BEFORE THE OHIO POWER SITING BOARD

In the Matter of the Application of)	
Kingwood Solar I LLC for a Certificate)	Case No. 21-0117-EL-BGN
of Environmental Compatibility and)	
Public Need)

NOTICE OF RESPONSES TO SECOND SET OF DATA REQUESTS FROM THE STAFF OF THE OHIO POWER SITING BOARD

KINGWOOD SOLAR'S JUNE 8, 2021 RESPONSES TO STAFF'S JUNE 1 AND JUNE 3 DATA REQUESTS

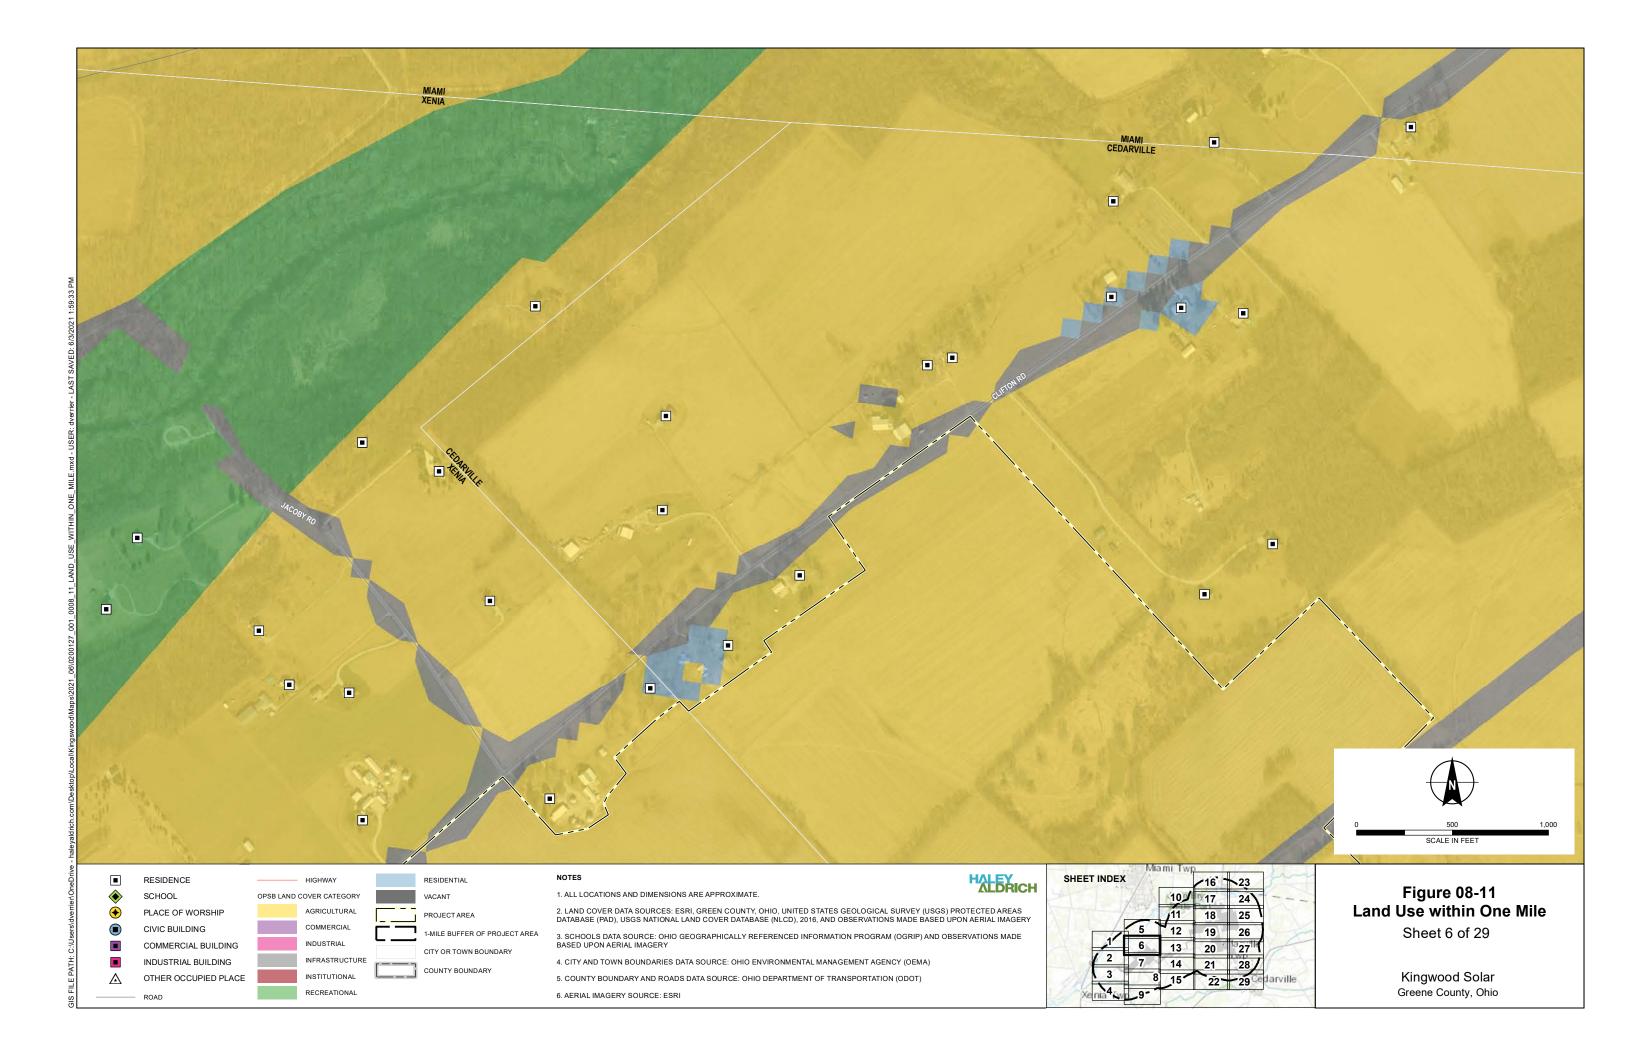
1. Figure 8-11 currently only delineates schools and residences. Amend Figure 8-11 to include the following structures depicted as points on the map, as per 4906-4-08(C)(1)(a): "...commercial centers or buildings, industrial buildings and installations,...hospitals, churches, civic buildings, and other occupied places".

A revised version of Figure 08-11 is attached that provides points on the maps for the requested features.

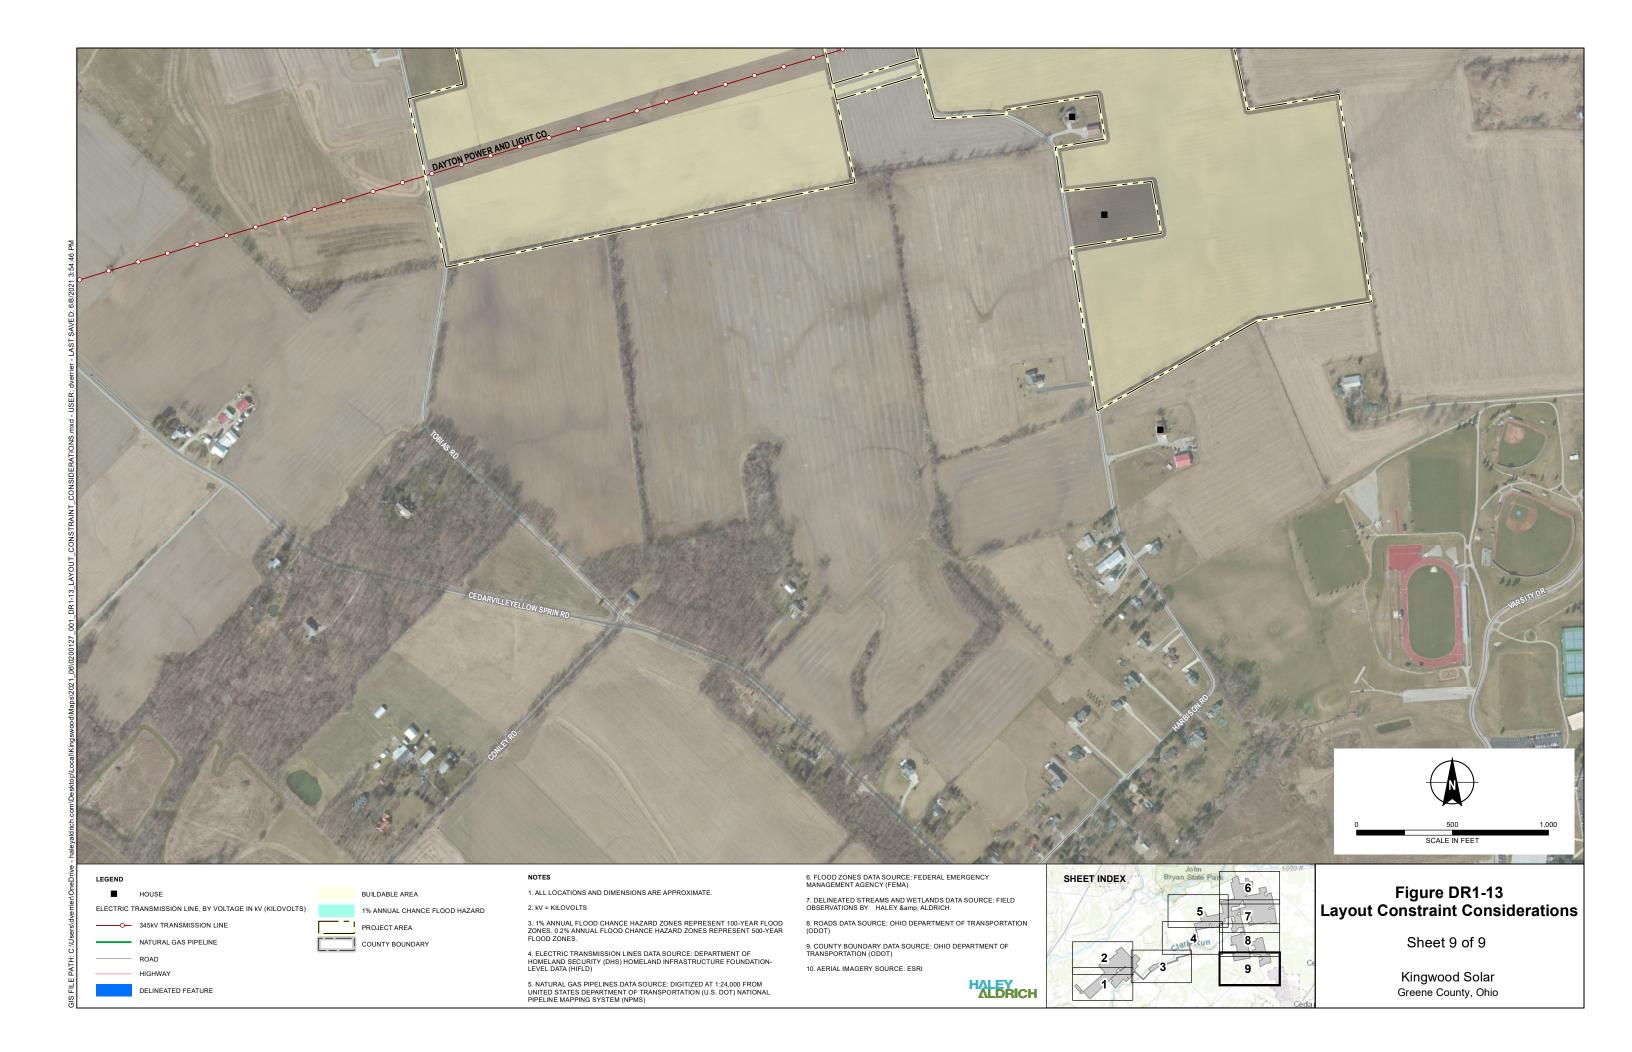
12. Please provide a buffer layer(s), in the form of shapefiles or .KMZ, of any setbacks applied to the project.

A shapefile package outlining the buffers around identified constraints is attached. In responding to this question, an error was identified on Figure DR1-13, which was provided with the responses to Data Request Set 1. A revised version of this figure is attached correctly illustrating a consistent 25-foot setback from the Project Area boundary. The shapefiles were also revised accordingly.
